ADDENDUM

Project: Iona South Heritage 09TSC

Addendum No.: Two

Date: April 25, 2017

Sheet:
A304

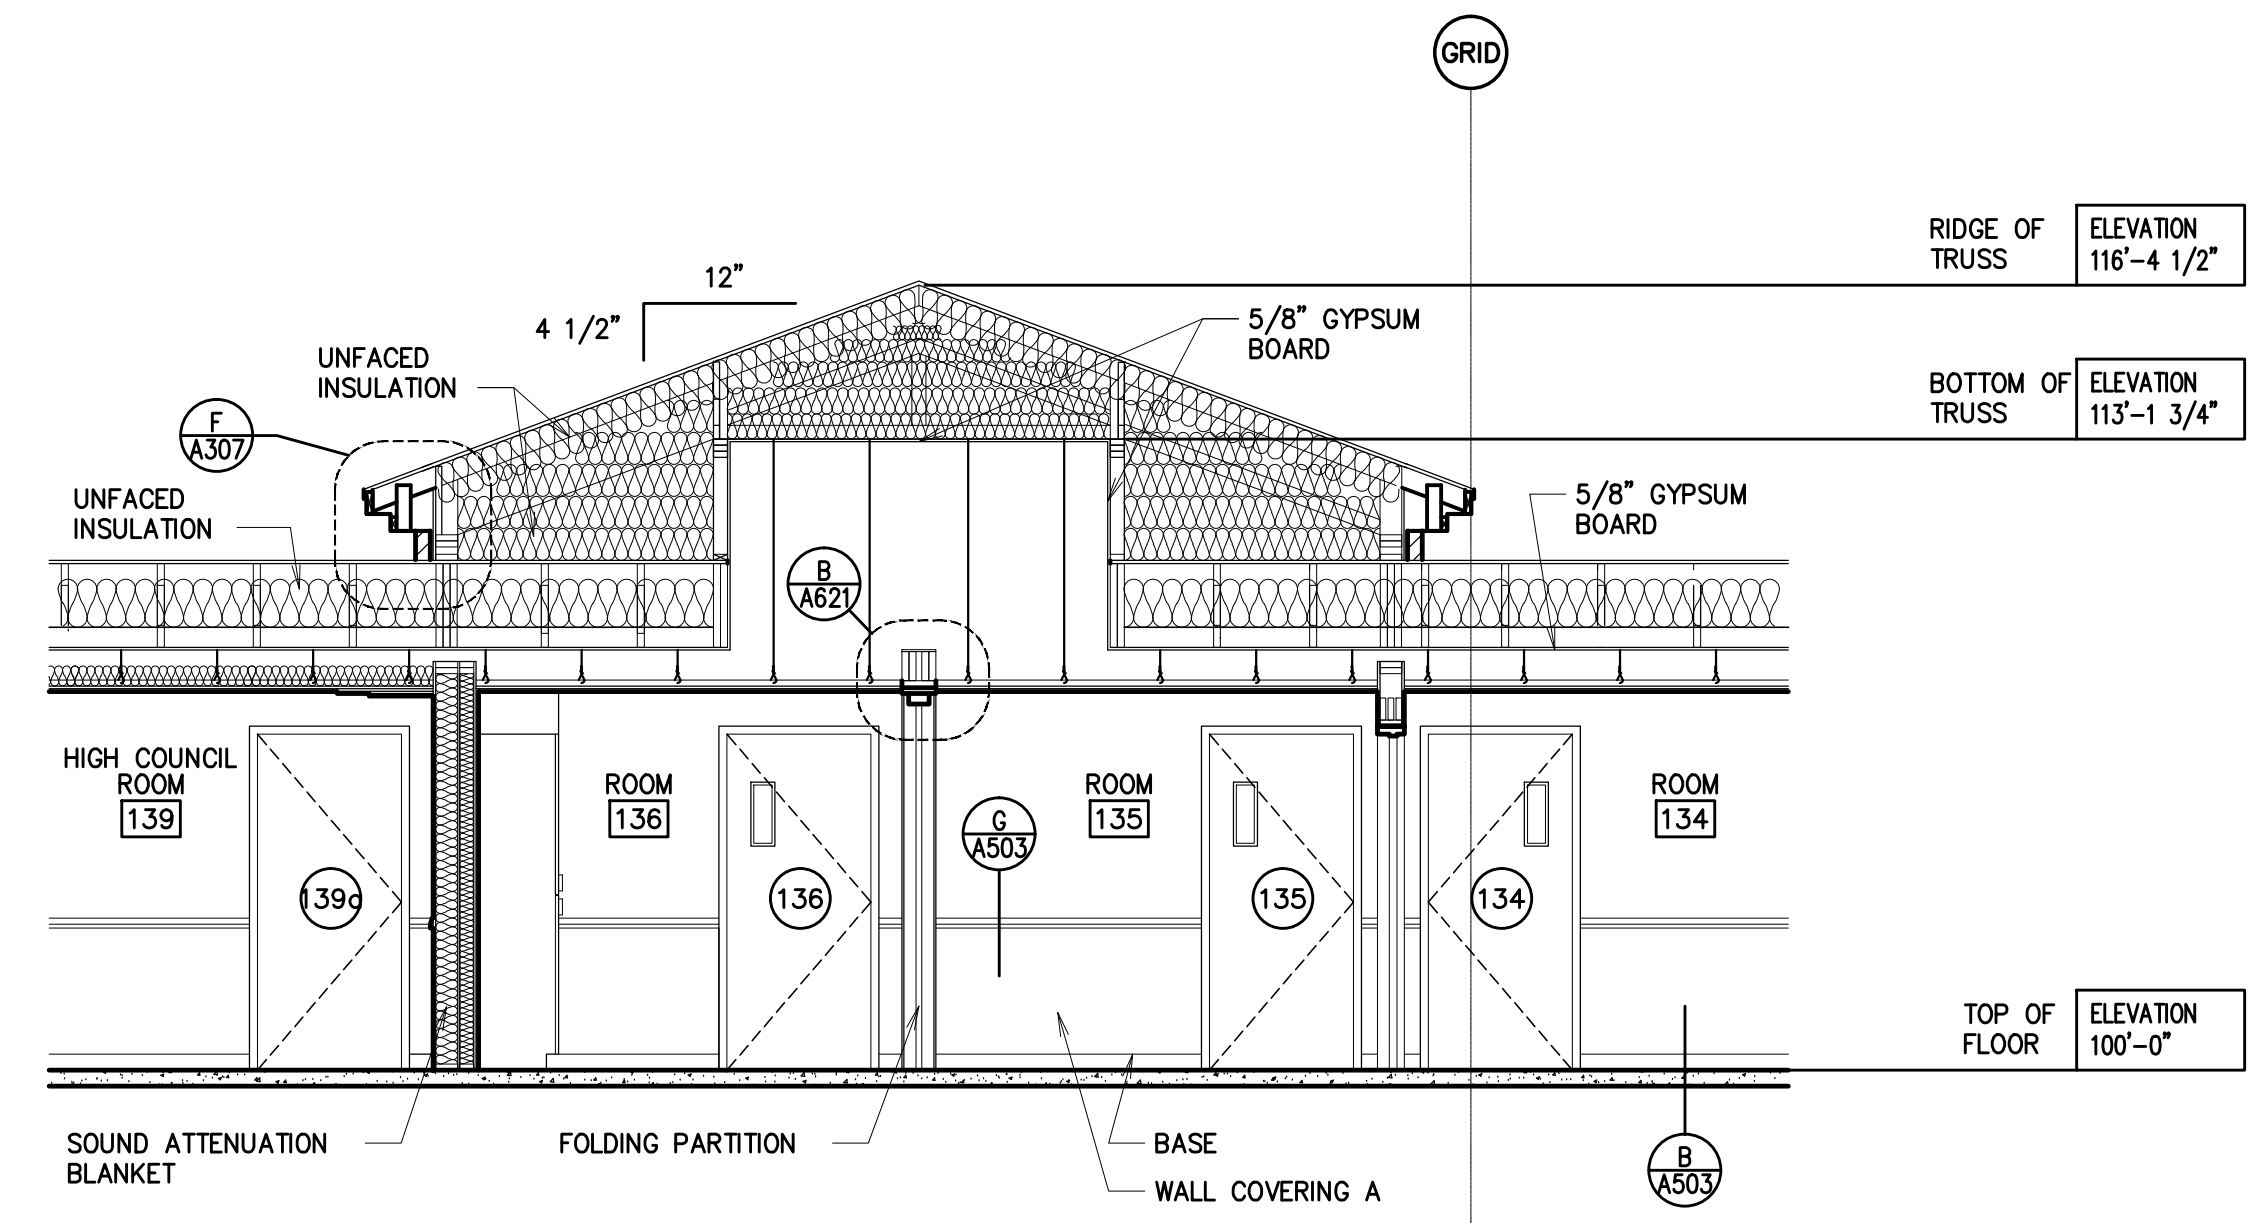
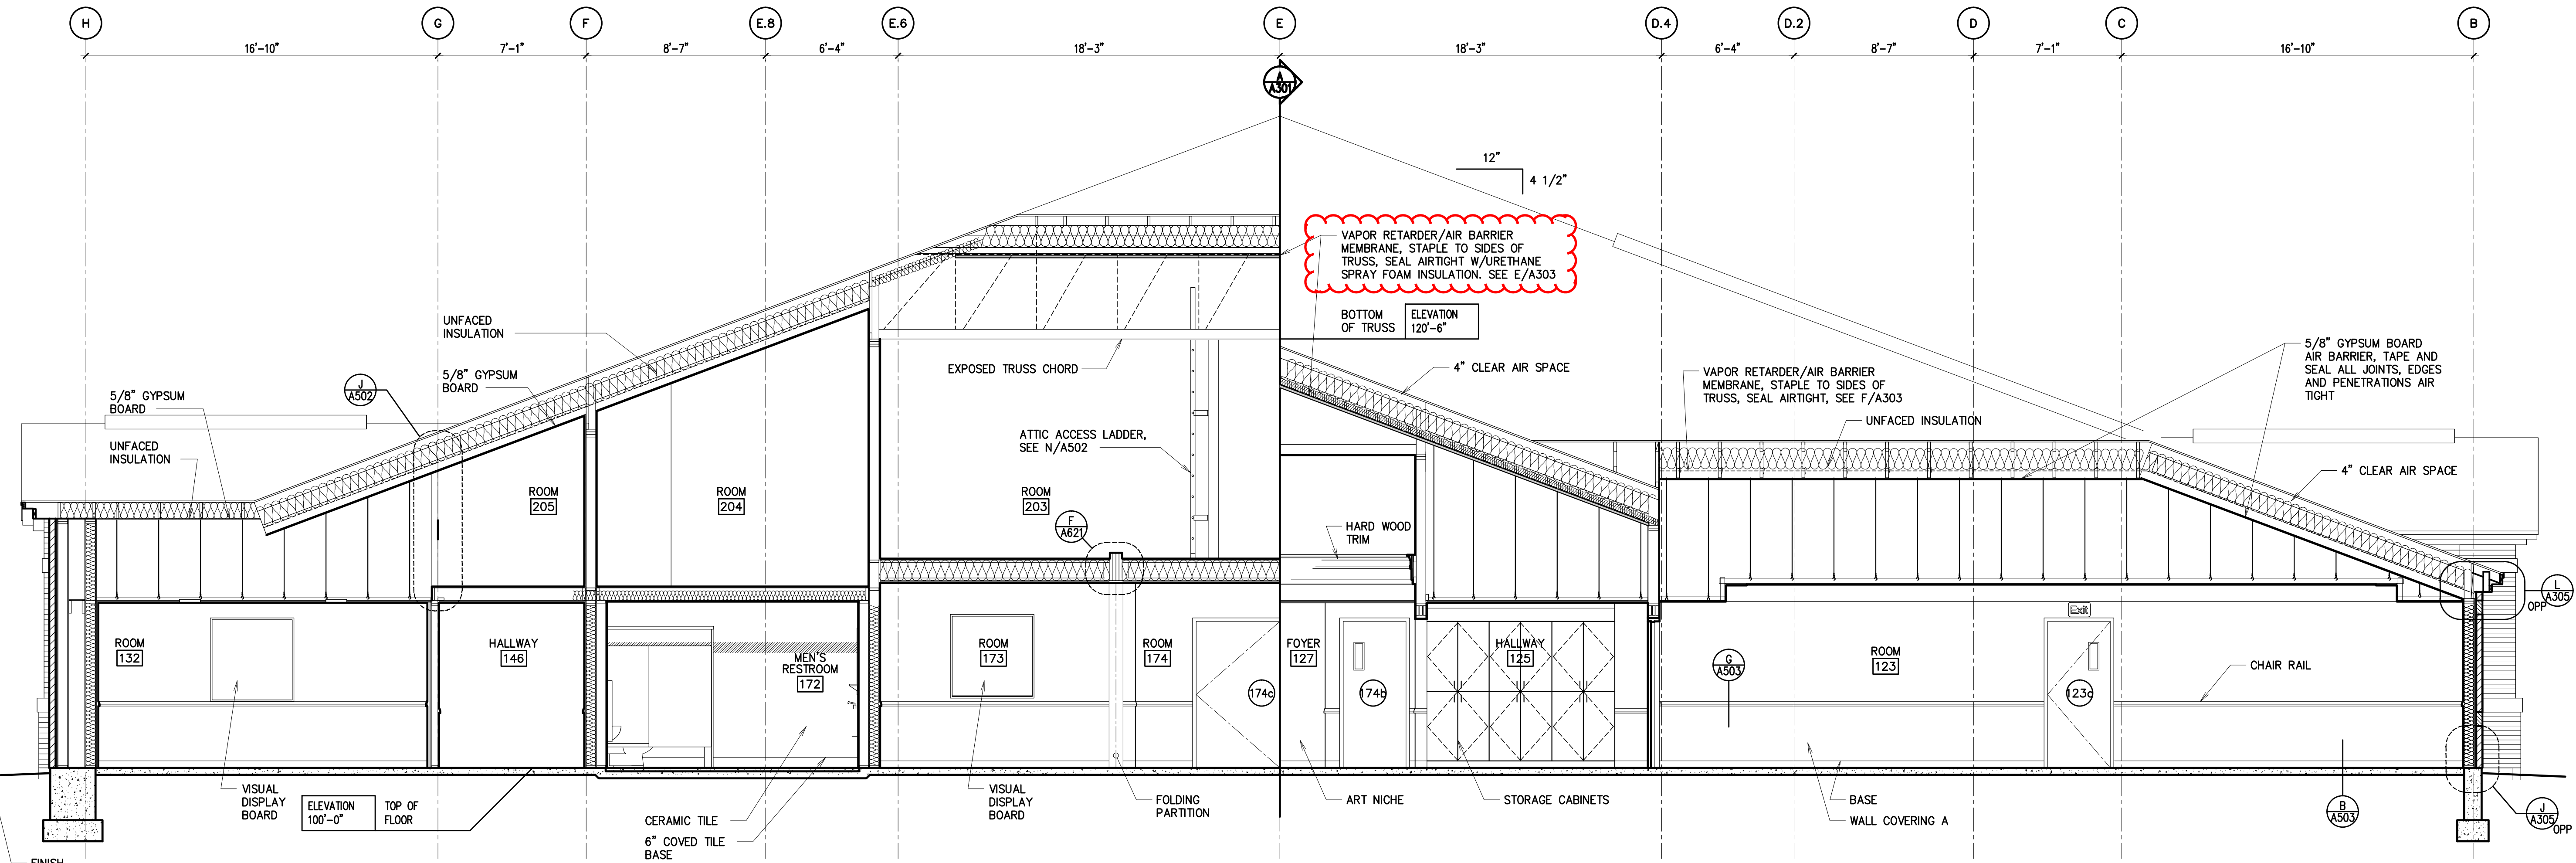
1. Sheet A302, Building Section A. Insulating spray foam extended on truss. See attached Sheet A302.
2. Sheet A304, Building Section B. Insulating spray foam added to trusses. See attached Sheet A304.

Sheet:
LP101

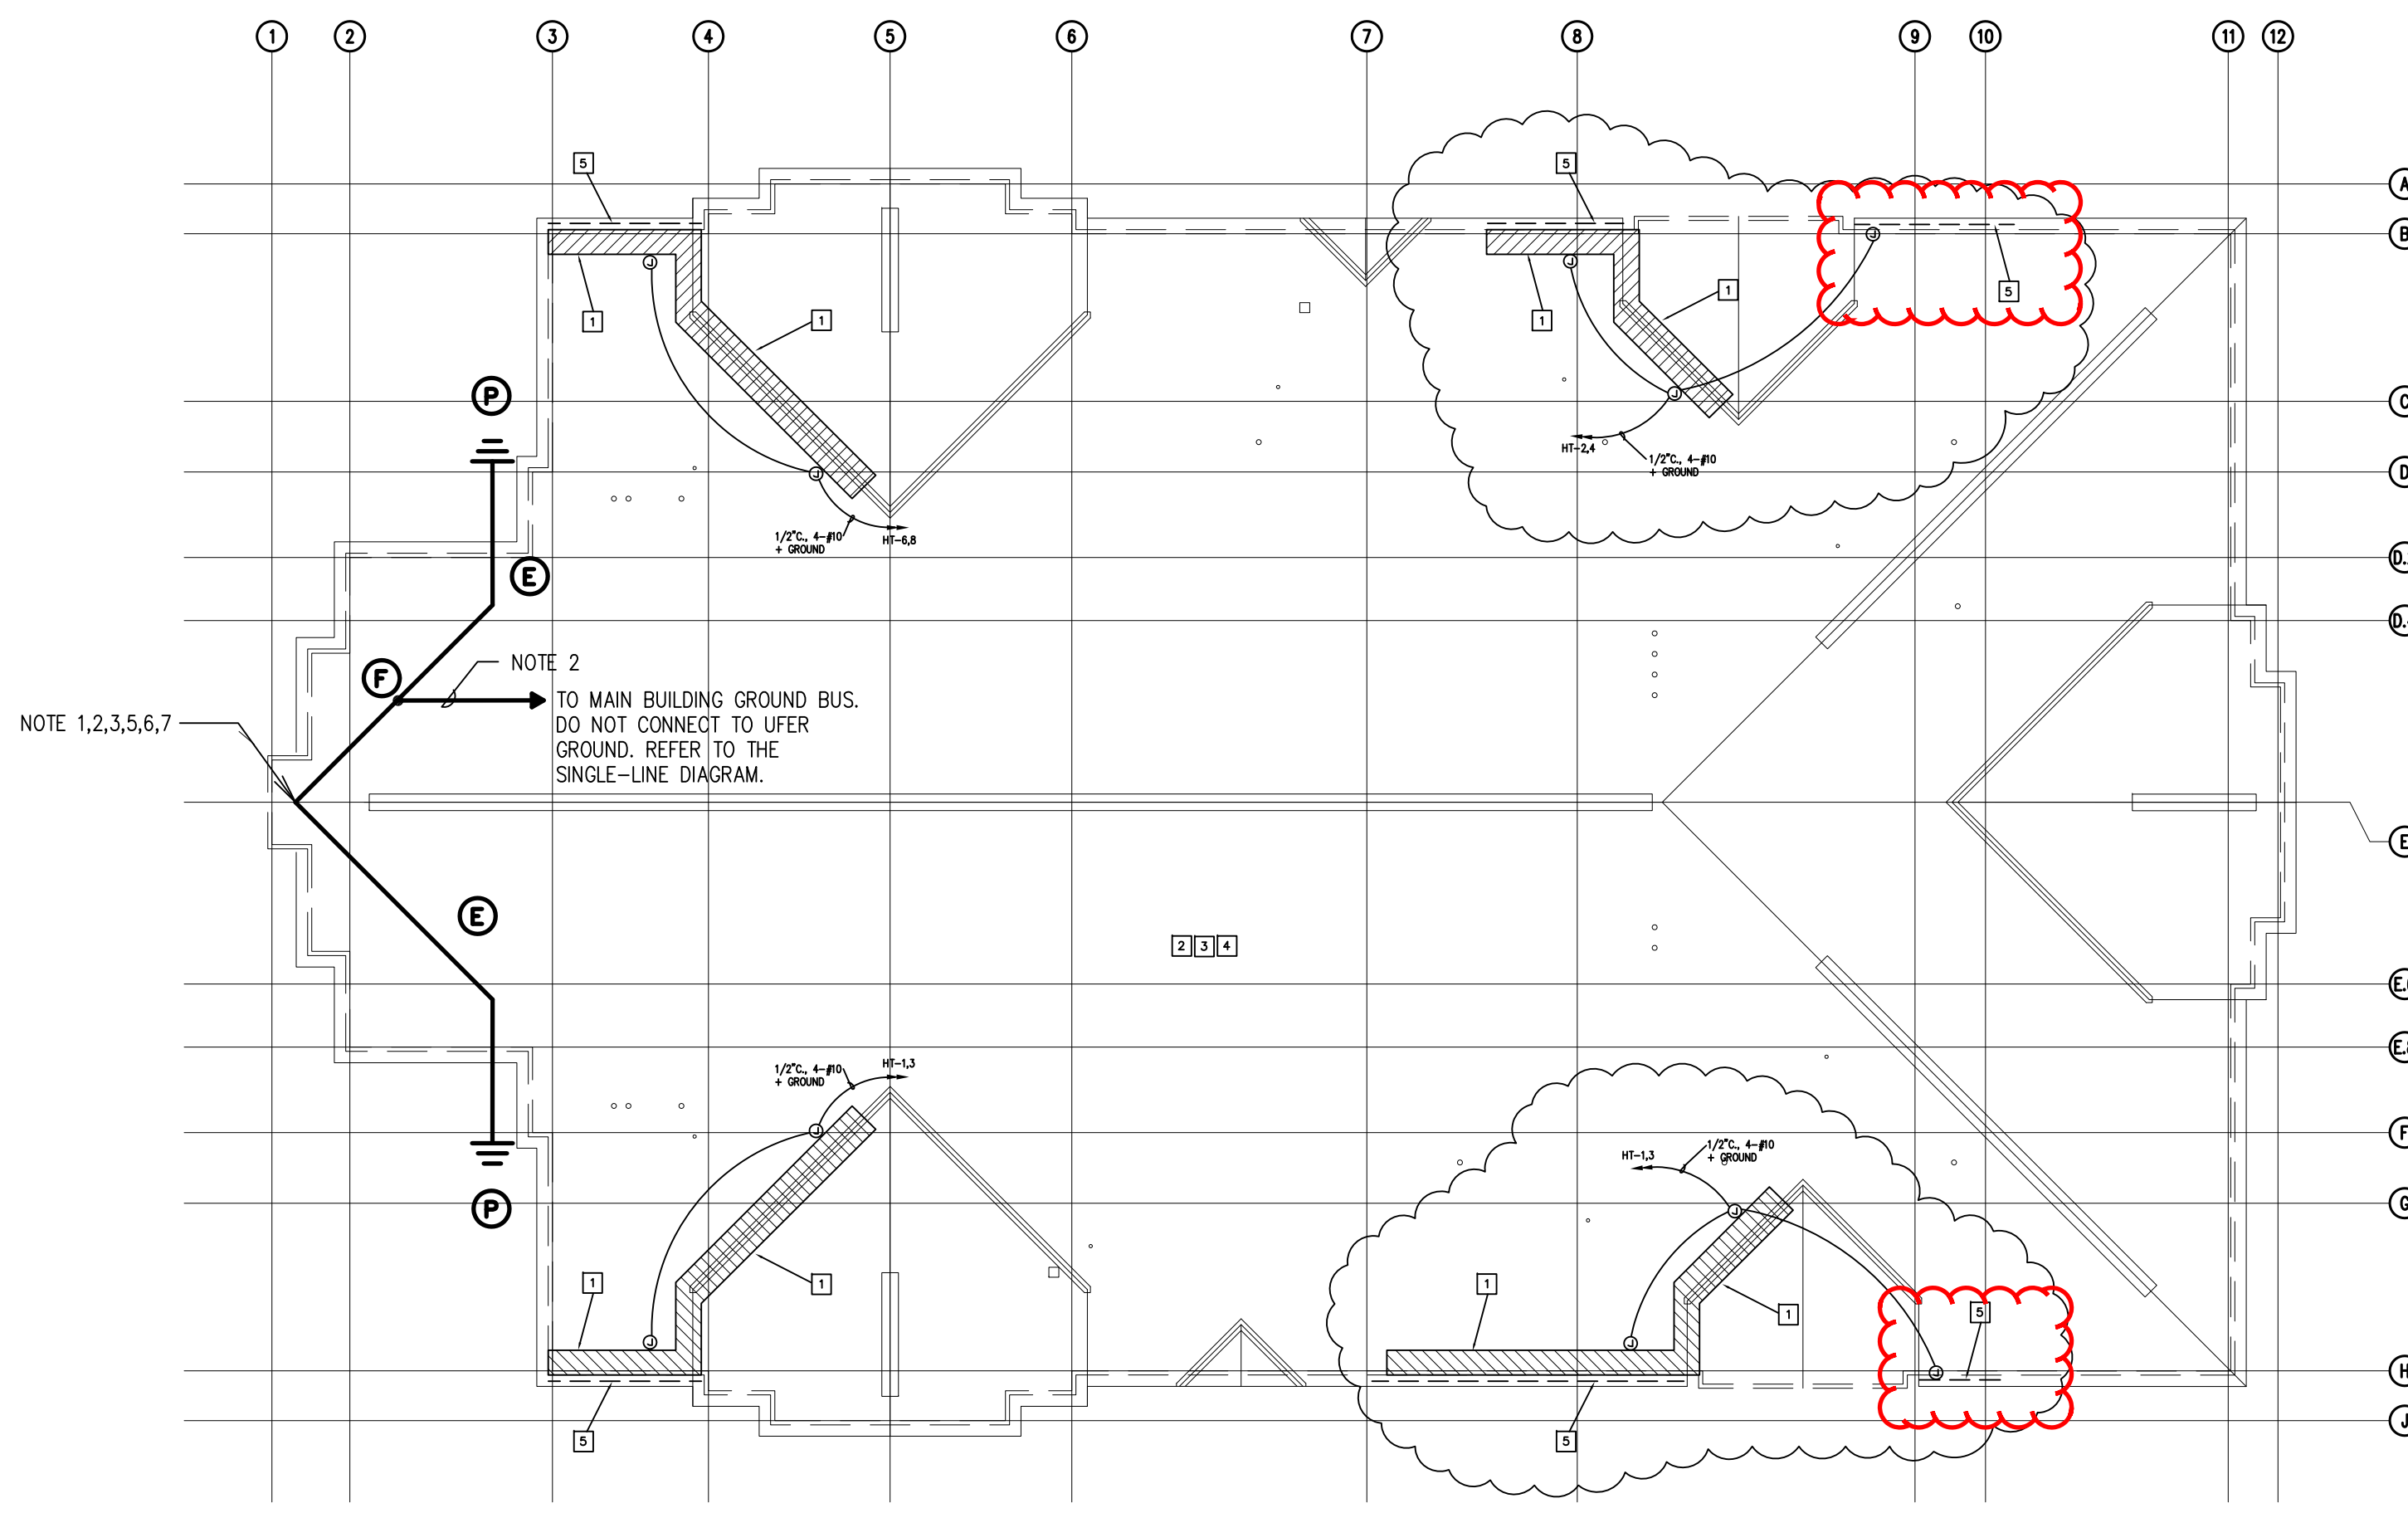
1. Sheet LP101 – Add heat trace to gutters and downspouts located south of the small gable overbuilds and over mechanical pad enclosures. See attached Sheet LP101.
